### **ADDENDUM #3**

#### **Rye City School District**

***Issued: 2021-02-11***

**This Addendum No. 3 forms part of the Contract Documents and modifies the original bidding documents dated, January 19, 2021.**

5 **HS Third Floor Caddy Storage Section**  
SCALE: 1" = 1'-0"

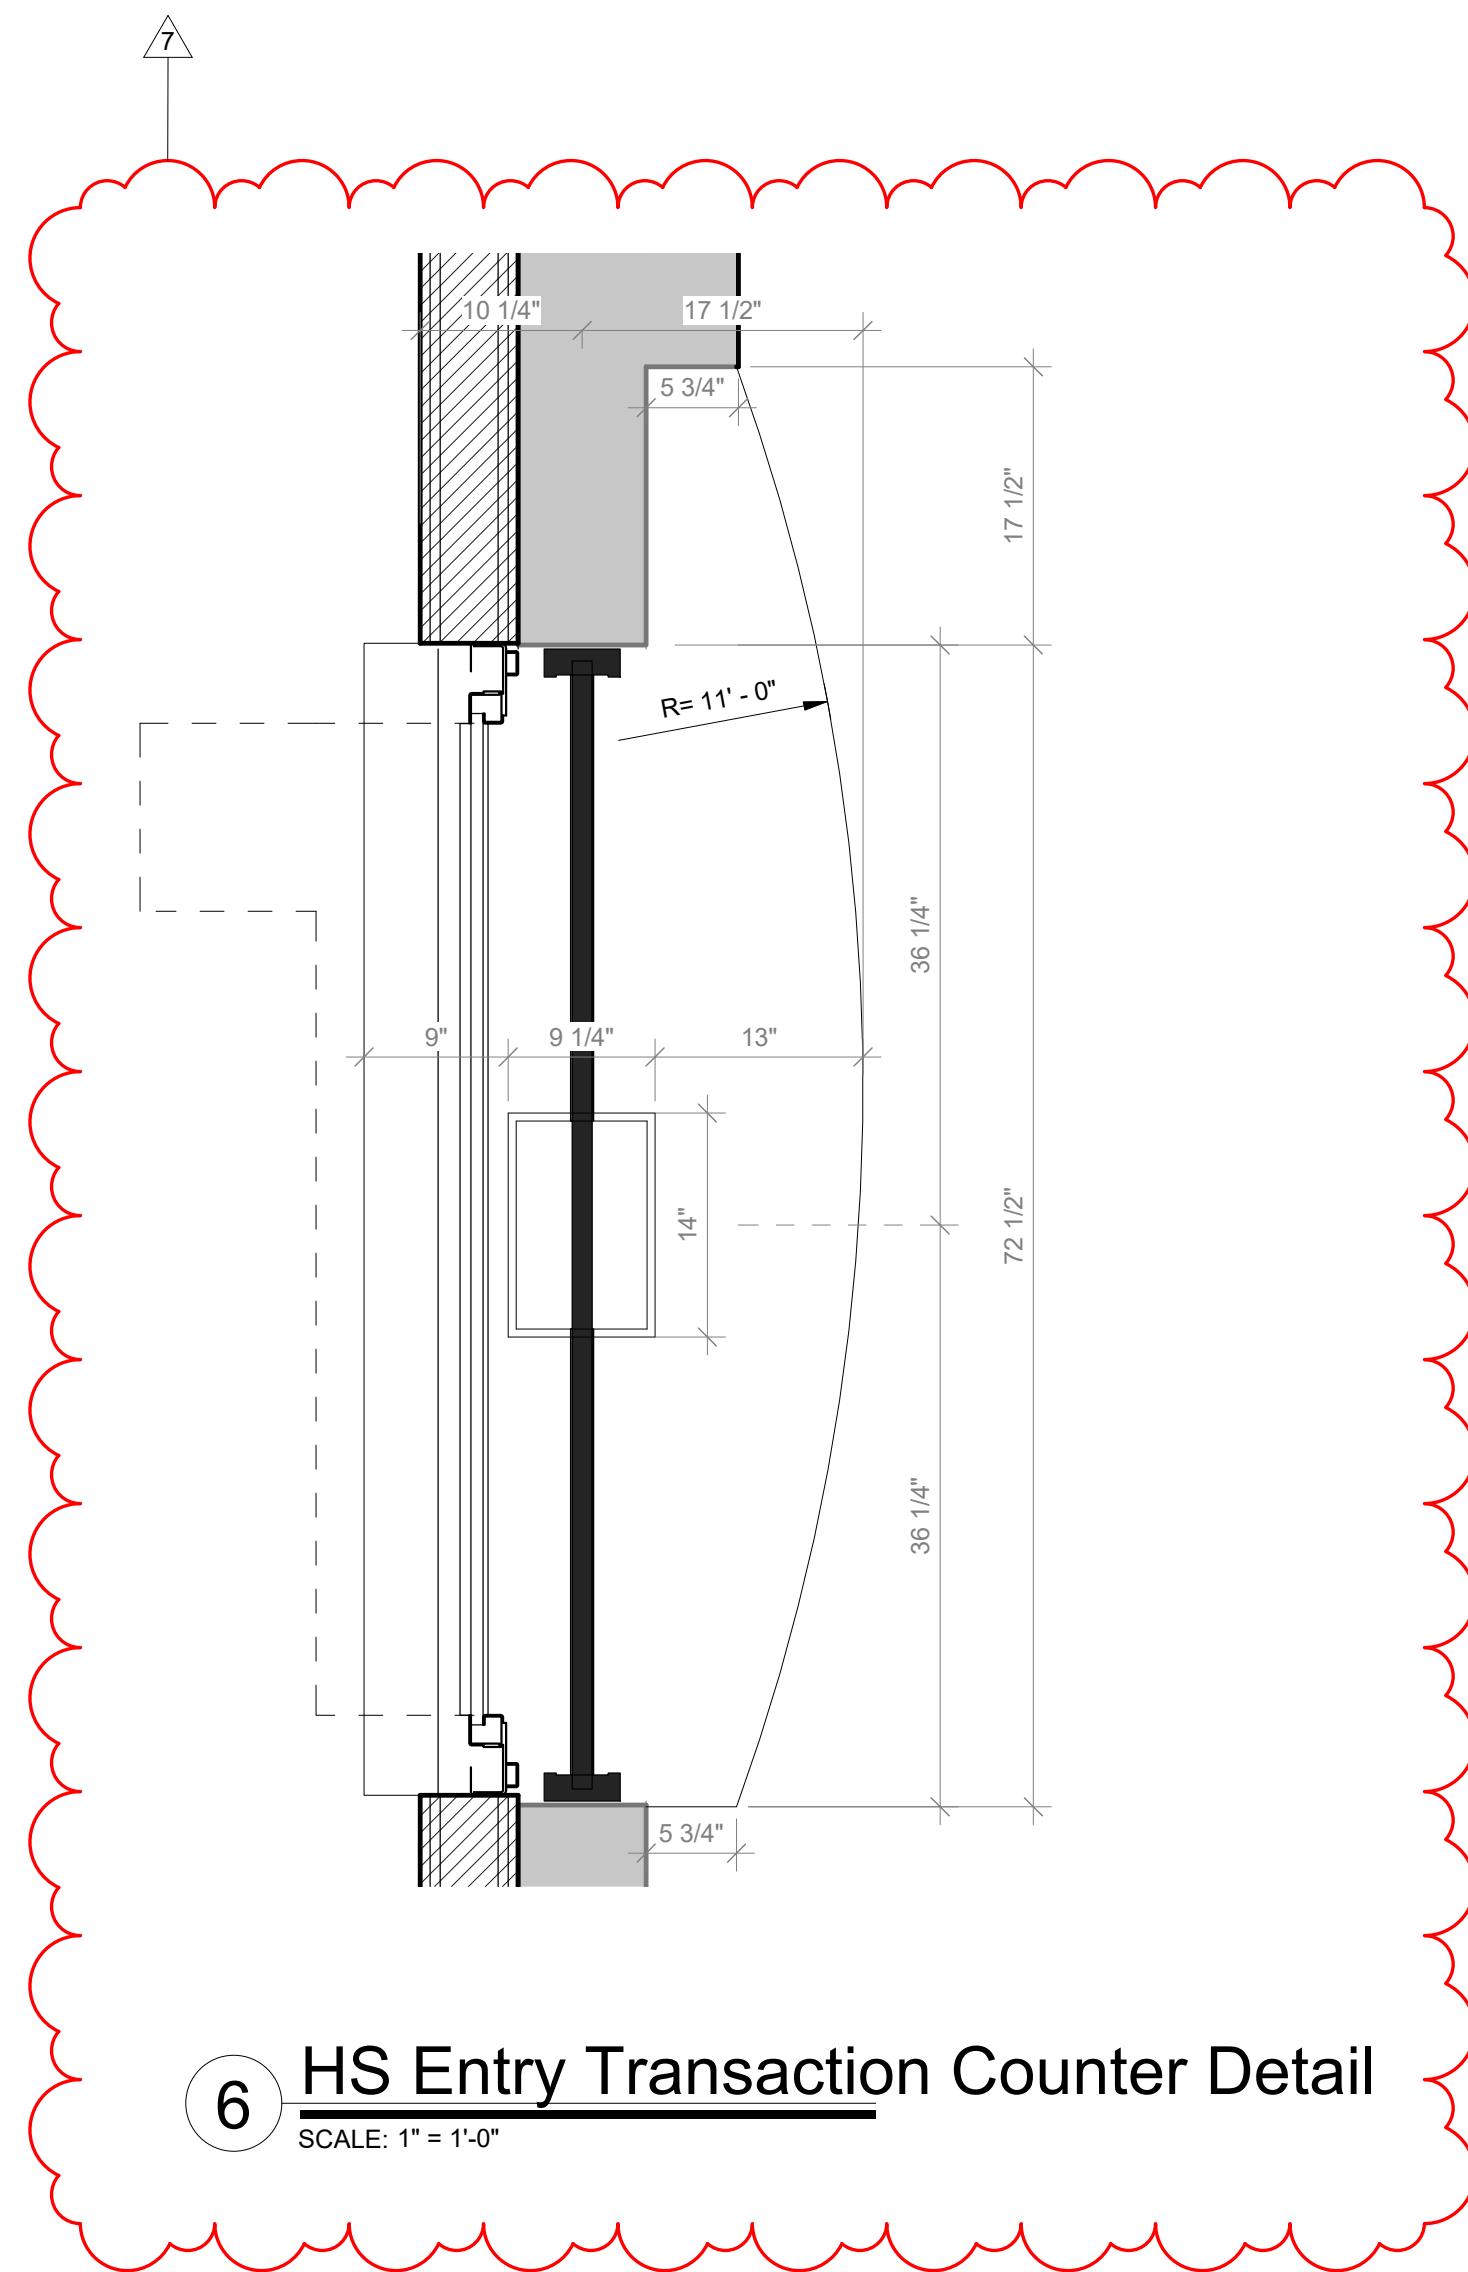
- a. Plan detail of HS Entry transaction counter added; Detail 1/A2-321 updated to remove built-in security desk.

Third Floor Power and Technology Plan -  
Alternate

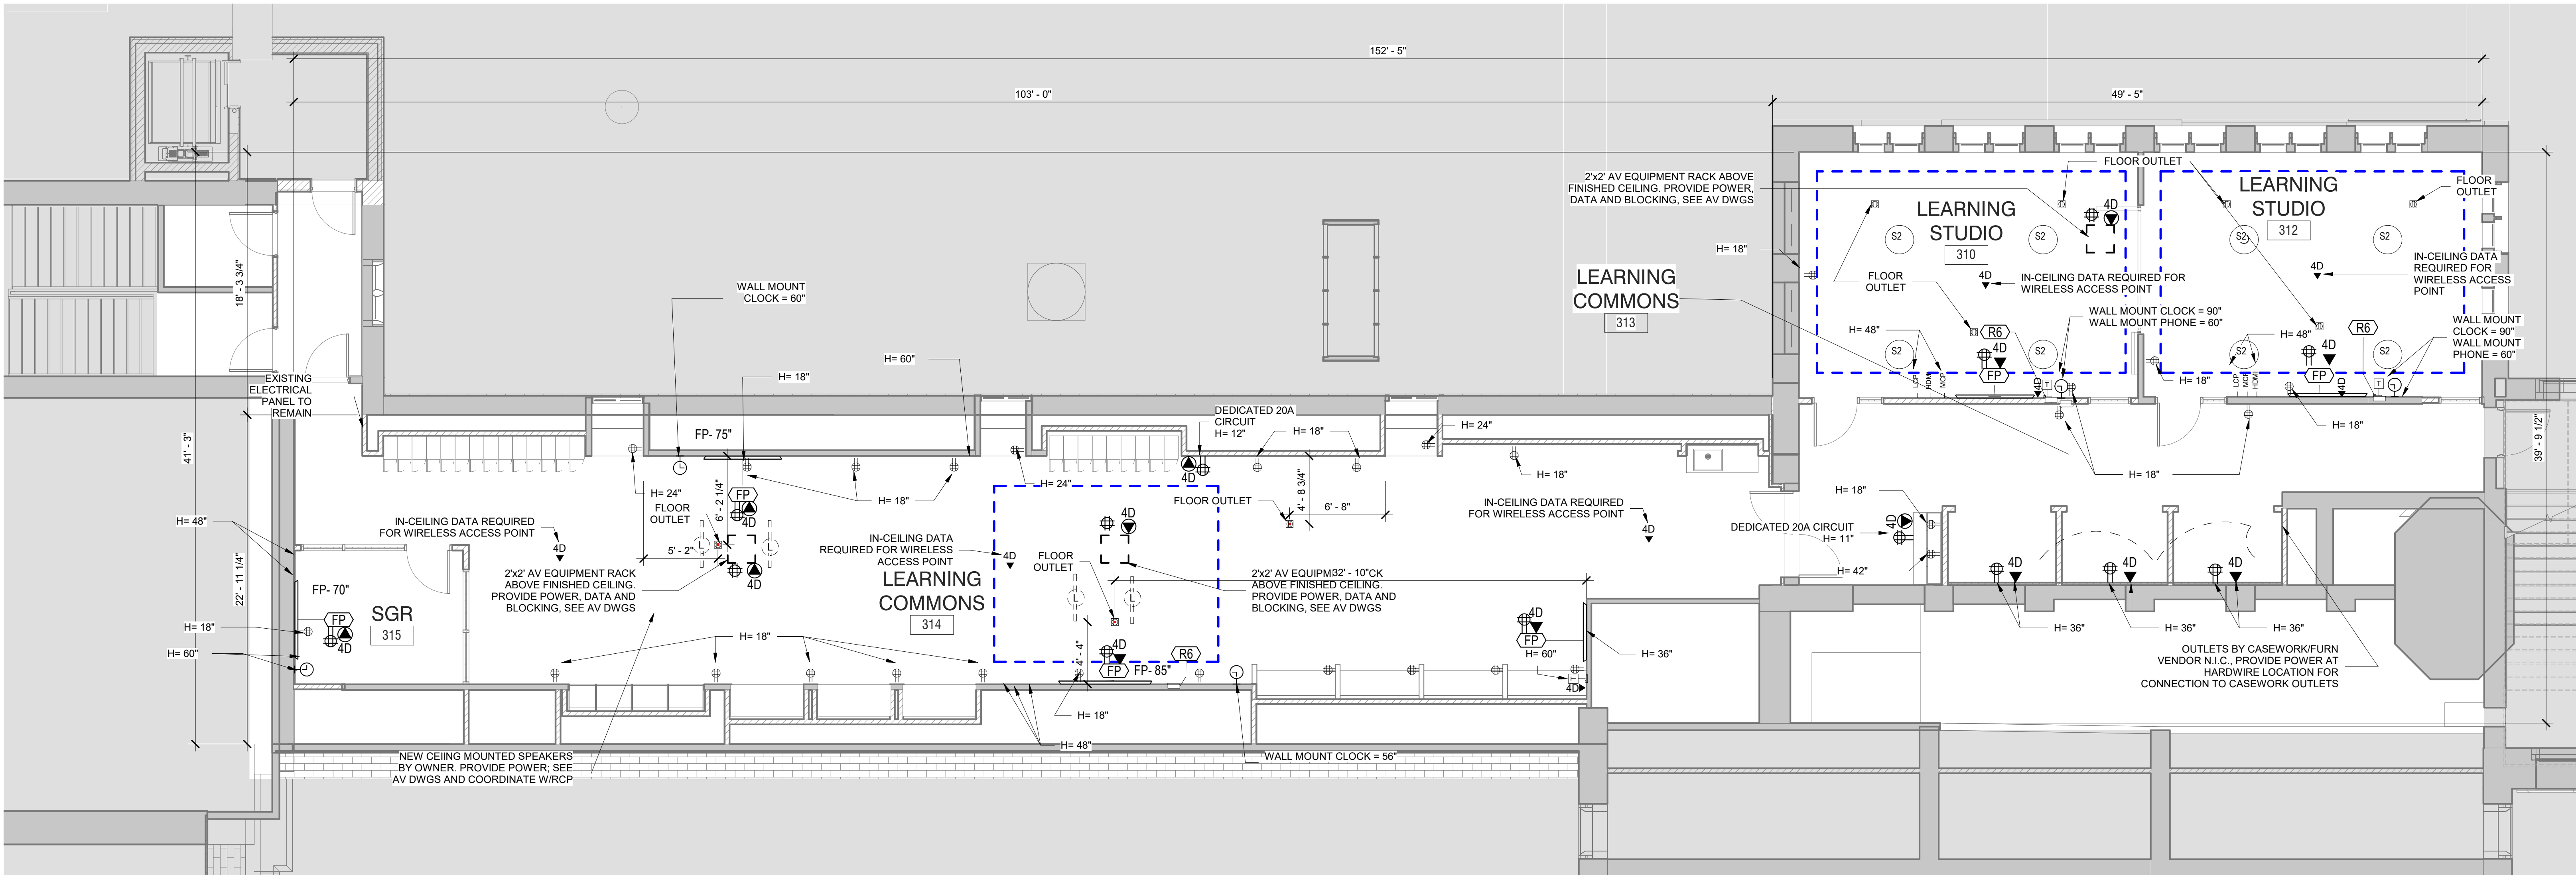
14. A2-523A:
  - a. Drawing added as alternate.
15. A2-924:
  - a. Project numbers corrected to show both Project 2 and Project 3 on sheet.
16. AVE2-001
  - a. Notes have been added to these drawings to clarify the scope of work between EC and Owner's AV vendor.
